# UNITED STATES PATENT AND TRADEMARK OFFICE

APPLICATION NO.	FILING DATE	FIRST NAMED INVENTOR	ATTORNEY DOCKET NO.	CONFIRMATION NO.
10/568,307	09/12/2006	Denis Pasquet	1107-060442	3388

<b>Office Action Summary</b>	<b>Application No.</b> 10/568,307	<b>Applicant(s)</b> PASQUET ET AL.	
	<b>Examiner</b> ANDREW YANG	<b>Art Unit</b> 3775

## **DETAILED ACTION**

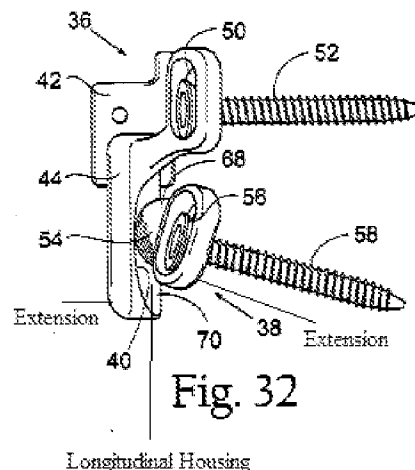
Reiley et al. discloses an intervertebral implant comprising a spacer having a body with a top end face 36 and a lower end face 38 opposite the top end face. The top end face 36 has a groove 42 wherein the groove comprises a first side and a second side. The first and second sides of the groove each have an opening (Figure 20). The lower end face 38 has a longitudinal housing extending orthogonally to the groove 42 and formed on a bottom end face of lower part 38 as seen in the figure below.

The implant can be implanted between the fifth lumbar vertebra and the sacral vertebra (Paragraph 20) where in a top portion will be in the longitudinal housing (Figure 38). It is noted that the illustrated figure does not show the sacral vertebrae, however, a top portion of the lower vertebrae in figure 38 is in the longitudinal housing.
